UTOPIA OFFICE – NEW PLANT EQUIPMENT NOISE ASSESSMENT

INITIAL REVIEW AND COMMENTS – REV A

7TH AUGUST 2020

5 Allowance for Plant Tonality

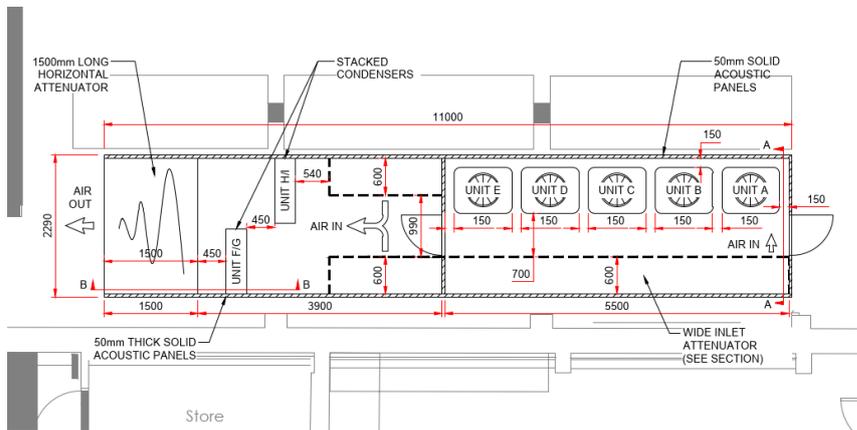
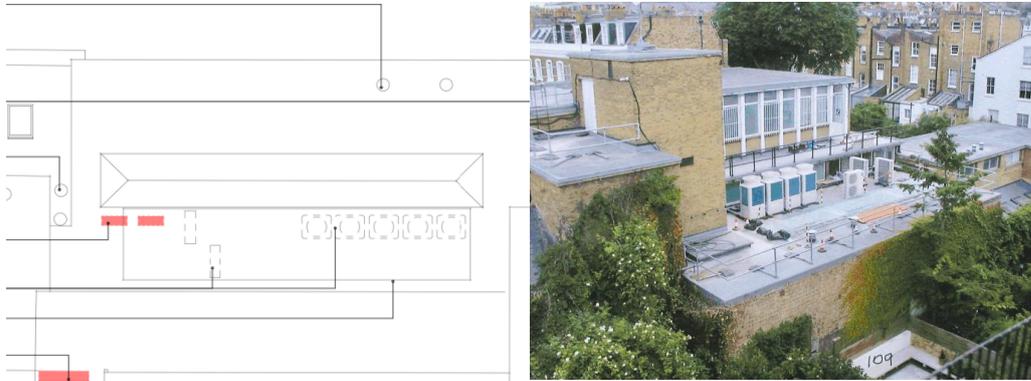
The assessment procedure follows that standard approach (as described in BS 4142). This standard recommends that a correction is made to noise levels to account for tonality. i.e. a penalty is applied to account for the fact that tonal noise has more potential to disturb than broadband noise. The assessment does not apply any correction for tonality, arguing (clause 7.3) that is “no evidence of any tonal content” for the proposed plant equipment. This is reasonable for the plant in isolation. However, the acoustic enclosure does not have a constant performance across the frequency spectrum. In effect, it applies a low-pass filter to the noise from the equipment and the resulting noise at the receiver position will be dominated by low-frequency sound. The figures given in Appendix 3 of the Plant Noise Assessment Report (Noico 72003022/1) suggest that the noise level at 63Hz will be 16dB higher than that at 125Hz. We would suggest that this runs contrary to the statement that there is “no evidence of any tonal content” and should be reviewed.

Possible action: Request that the correction for tonality is applied to the noise after the inclusion of the effect of the enclosure.
